CITY COUNCIL ACTION FORM

DEPARTMENT	PRESENTED BY	DATE
Planning	Kristi Jefferson - Senior Planner	December 6, 2022

Ordinance 2022-21 – Second reading and Public Hearing for the 505 Oak Street Major Impact Review application for a Planned Development Overlay and Major Subdivision of the property located at 505 Oak Street.

PRELIMINARY SUBDIVISION PLAT

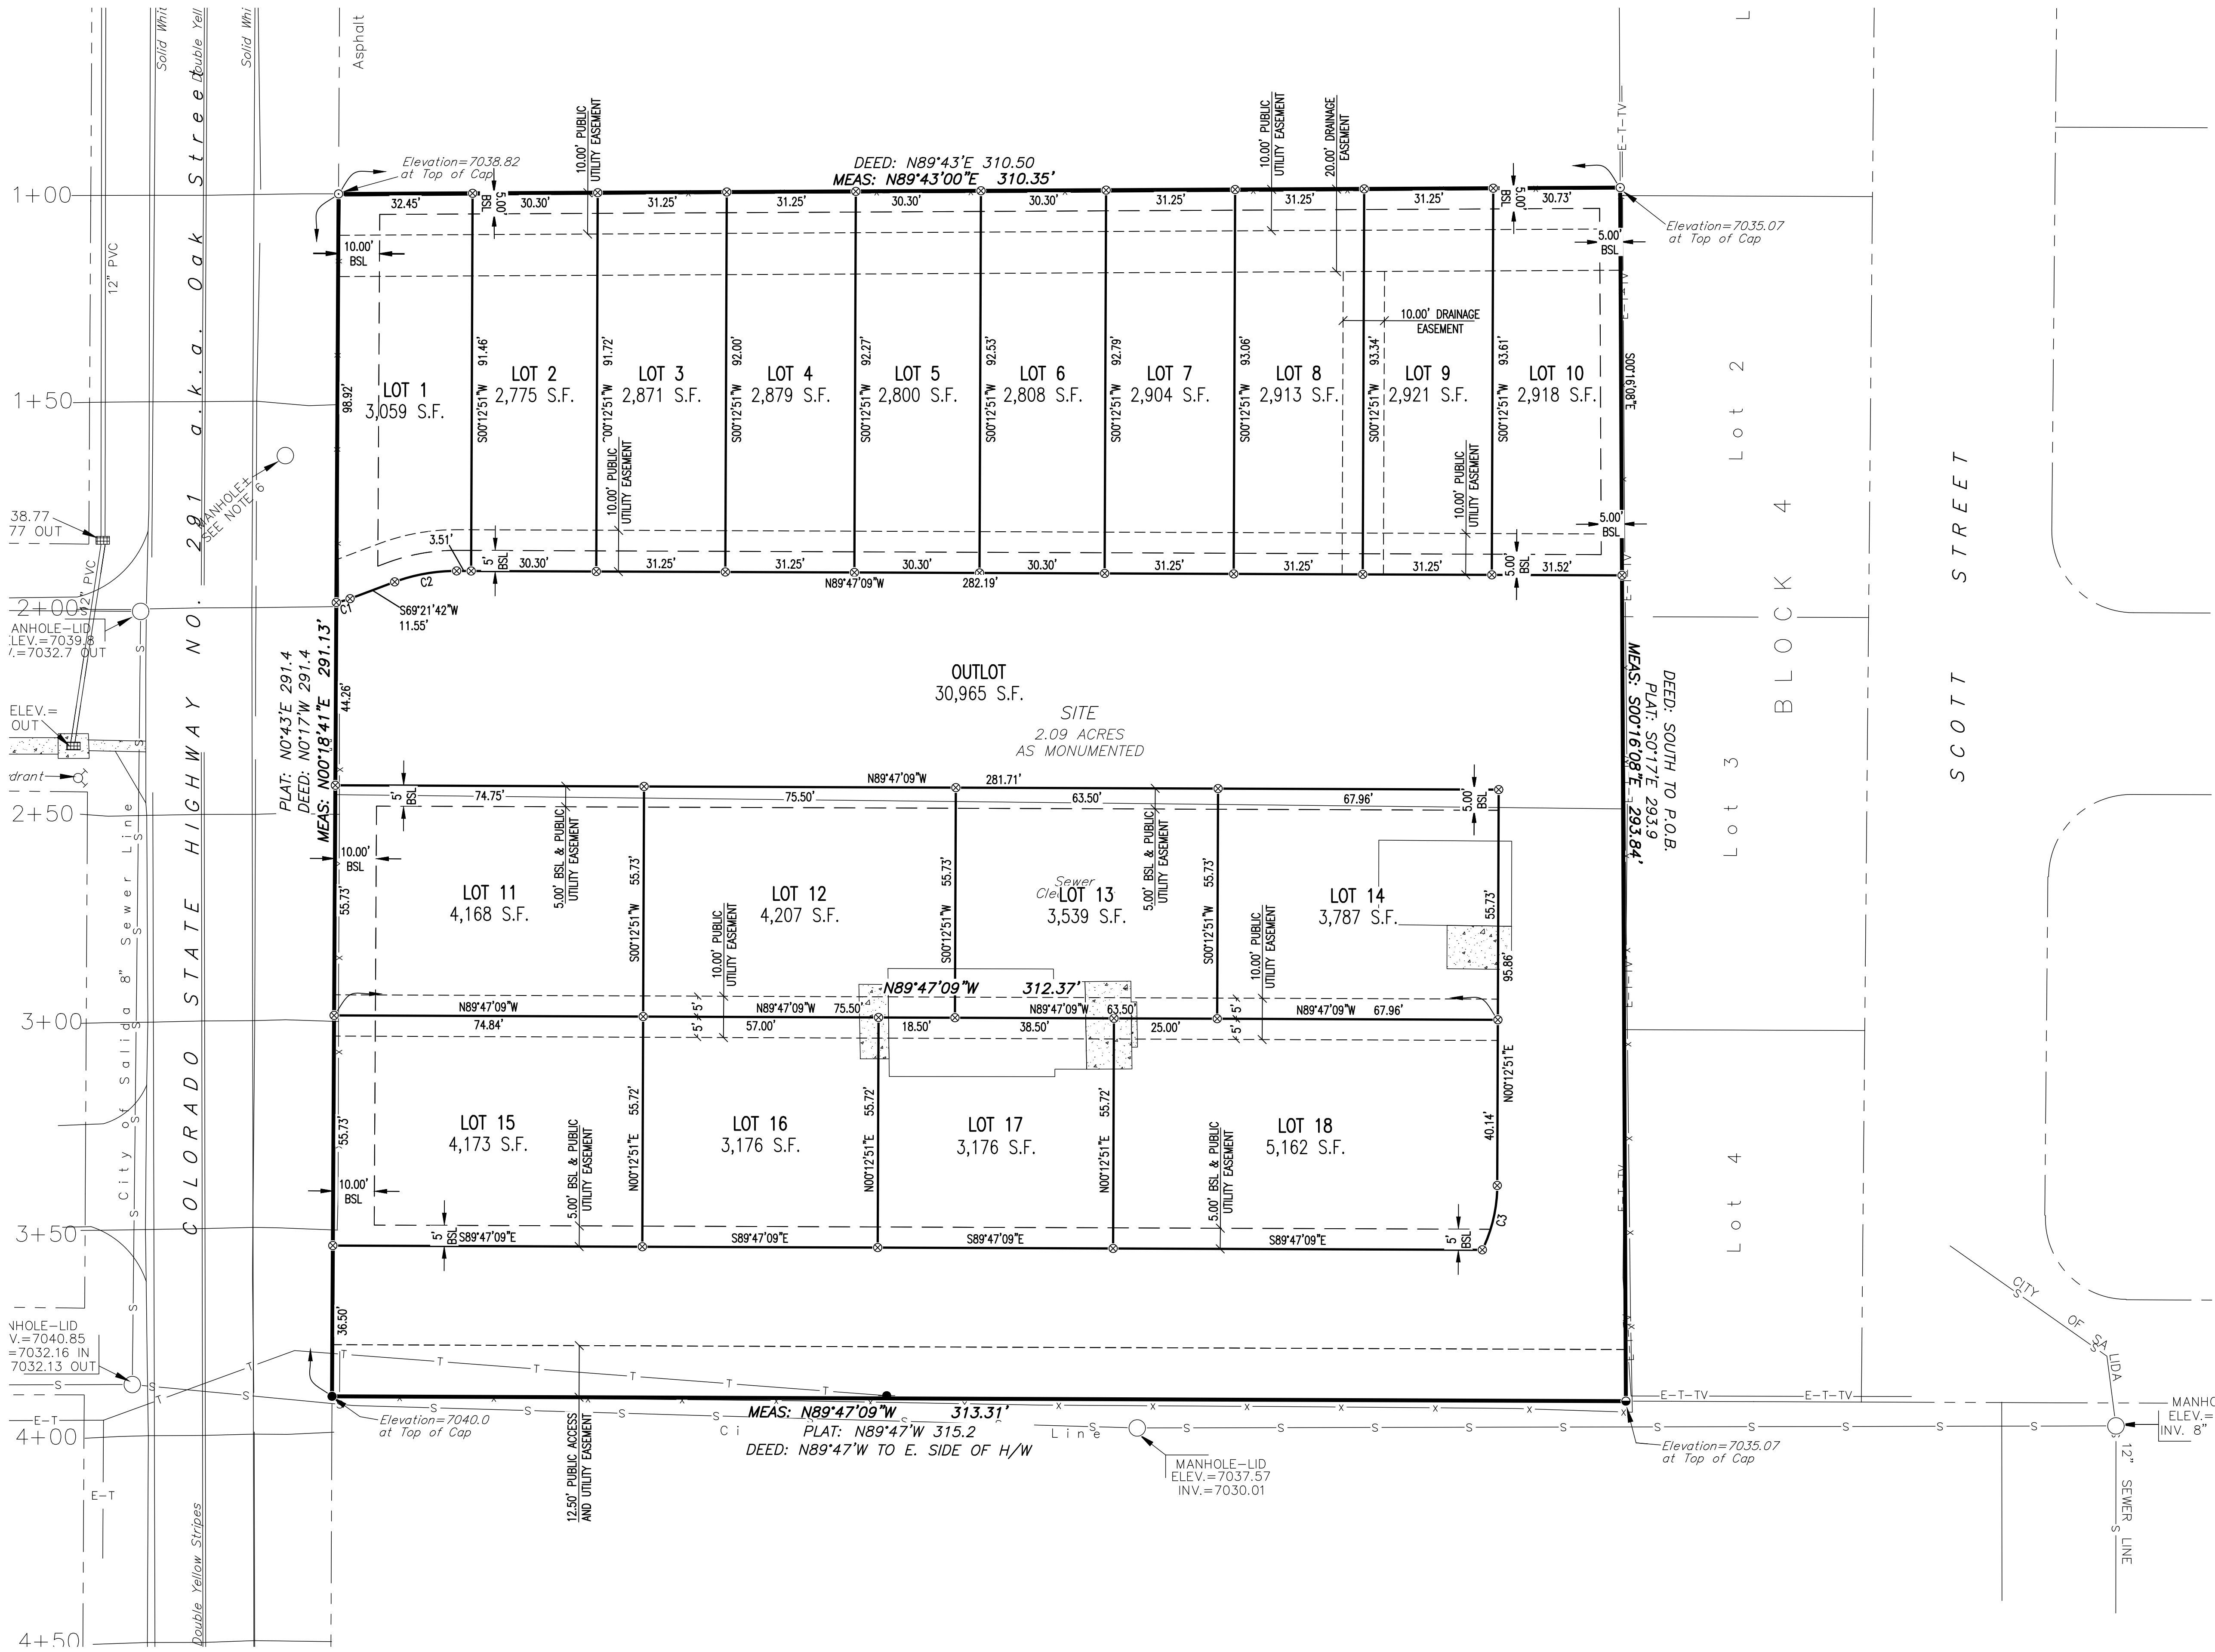
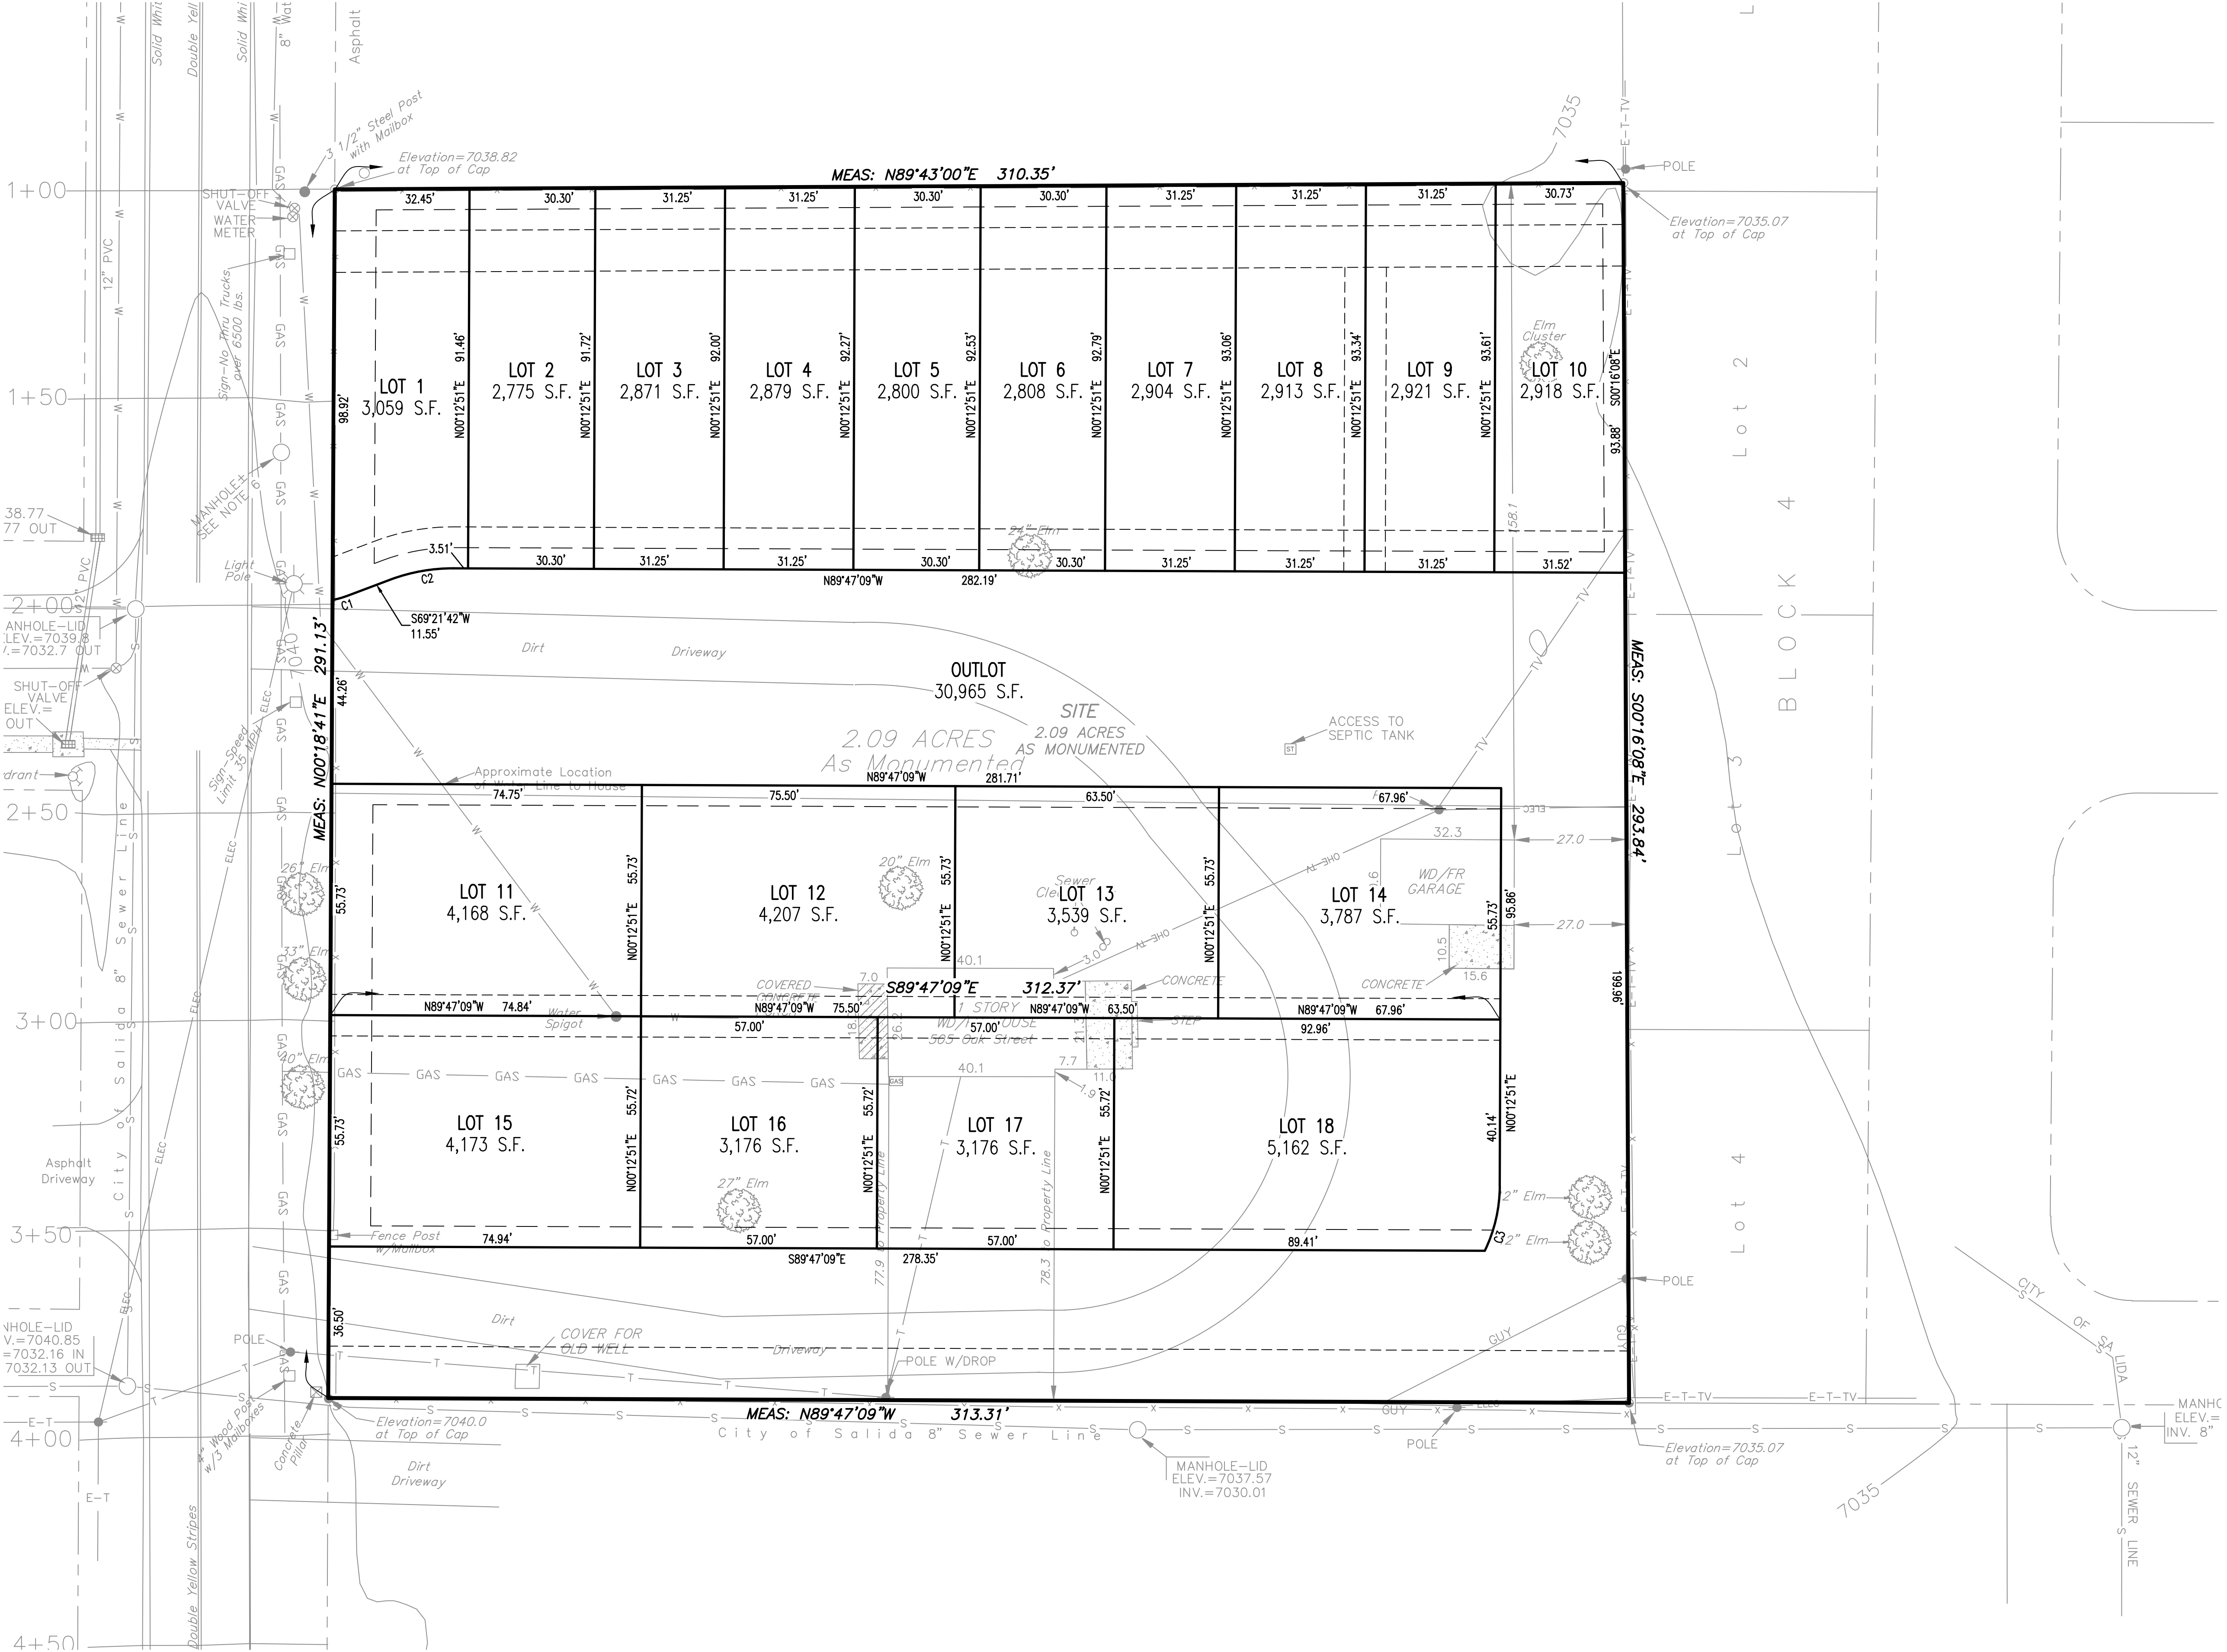
The private road is shown on the plat as an out-lot. This is not considered an “out-lot” but a private road. The plat will need to be updated to remove “out-lot” and have the private road named.

2. Assuming (again hopefully accurately) that the Outlot contains utility easement, what are the developer's thoughts of natural gas lines being buried under asphalt? Will it be acceptable to cut asphalt in order to install service lines? Or will it be expected to have natural gas stubbed into each structure (finished or not) prior to paving? If the latter is correct, I will defer to Atmos Ops Supervisor in the area to comment on the feasibility of that request.

3. A name for the private road be added to the plat and "out-lot" removed.

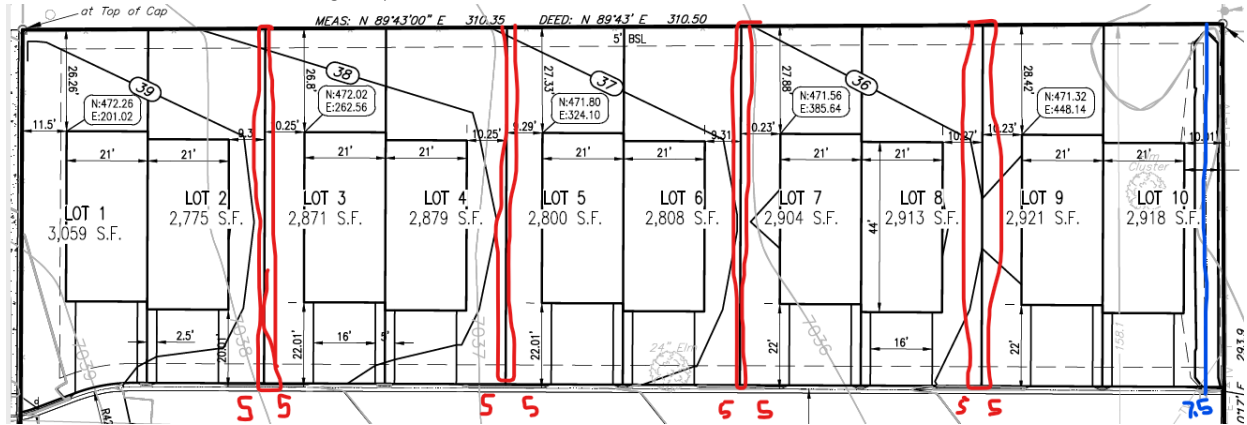
5' rear lot easements on all rear lots

Lots 11-18 5' side lot easements. For side easements see below for lot 1-10

Customer to relocate or remove existing utility lines into easements at their cost.
